TECHNICAL SERVICES BULLETIN 15-01

Low Profile Remote Control Safety Pilot System with Variable Flame Height Control #APK-17

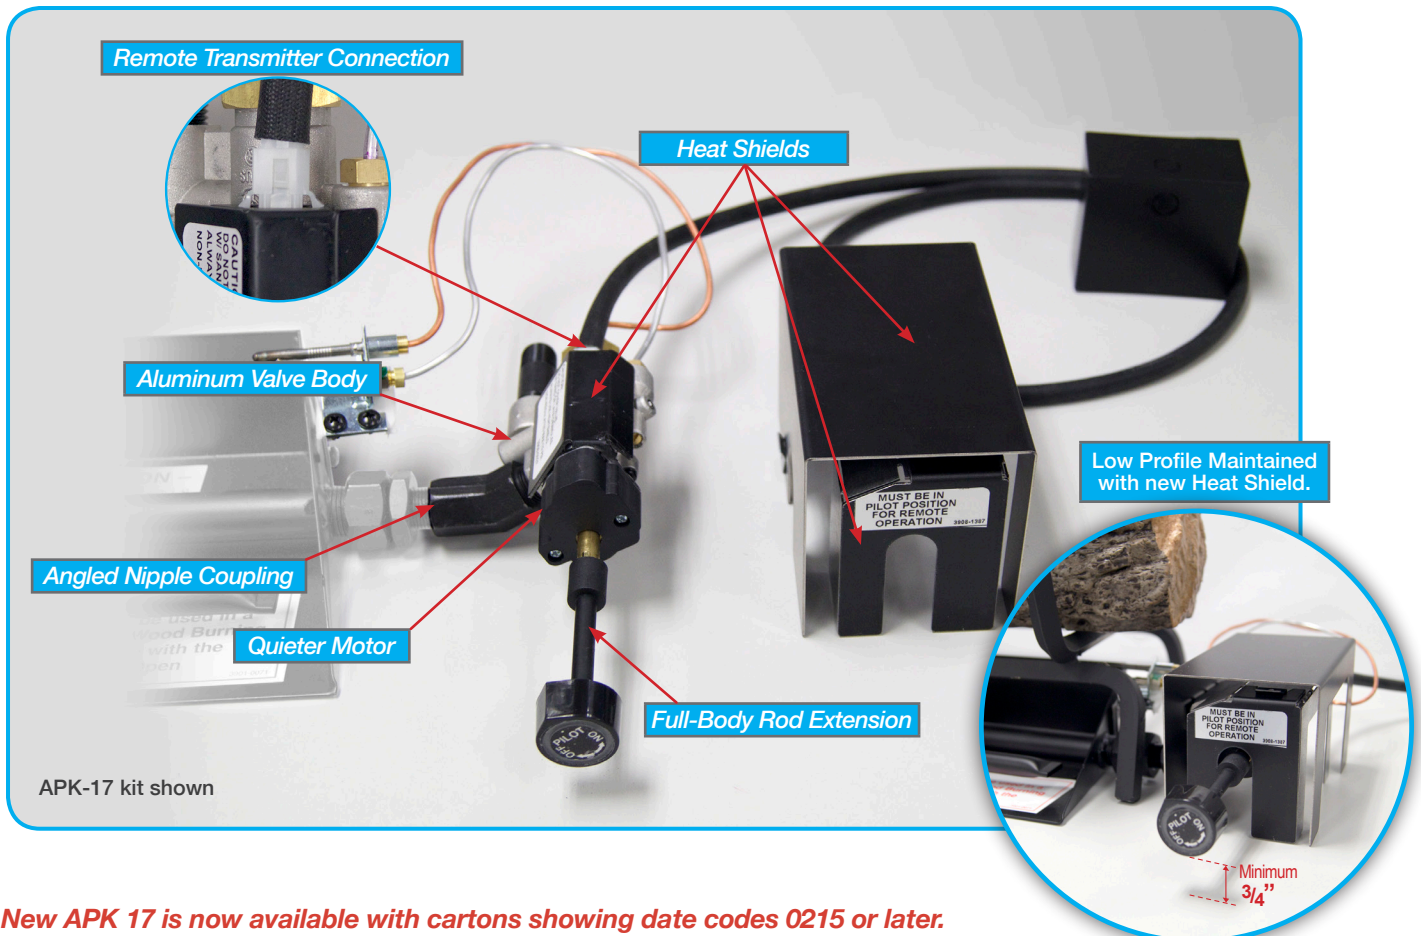
Building on the chassis we introduced last year, the 2015 improvements make installation easier, ensure trouble free operation and maintain a low profile design.

- Better designed triple heat shield to keep the valve cool (January 2015)
- New angled nipple coupling elevates the valve a minimum of 3/4" above the fireplace floor for easier installation and to help keep it above sand and other media that can interfere with operation (January 2015)
- New full body rod extension for better valve rotation (January 2015)
- Aluminum valve body for greater heat dissipation (January 2014)
- Sealed gear housing to prevent sand or other debris from interfering with valve operation (2013)
- Quieter, more efficient motor for greater battery life (2011)
- Remote transmitter connection to the valve heat shield for easier installation (2011)
